ADA Curb Ramp New Construction Inspection Form (Parallel)

Glencoe

24952.54

Cottage

PARALLEL RAMP (PL)

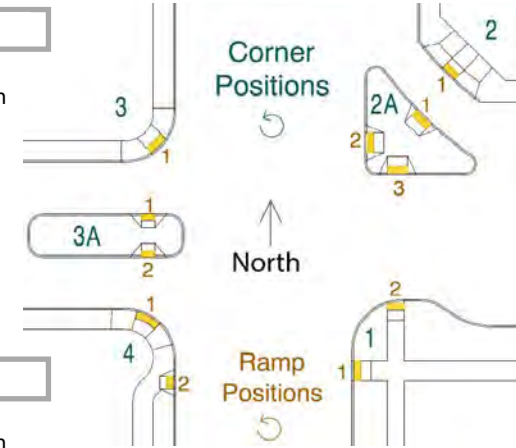
2.3 $\leq 2.0\%$ ☐ $> 2.0\%$ ☒

☐ 13.42 $\leq 8.3\%$ ☐ $> 8.3\%$ ☒

6.7 $\leq |5.0\%|$ ☐ $> |5.0\%|$ ☒

2.3 $\leq 2.0\%$ ☐ $> 2.0\%$ ☒

IITD,grater than2" behind curb
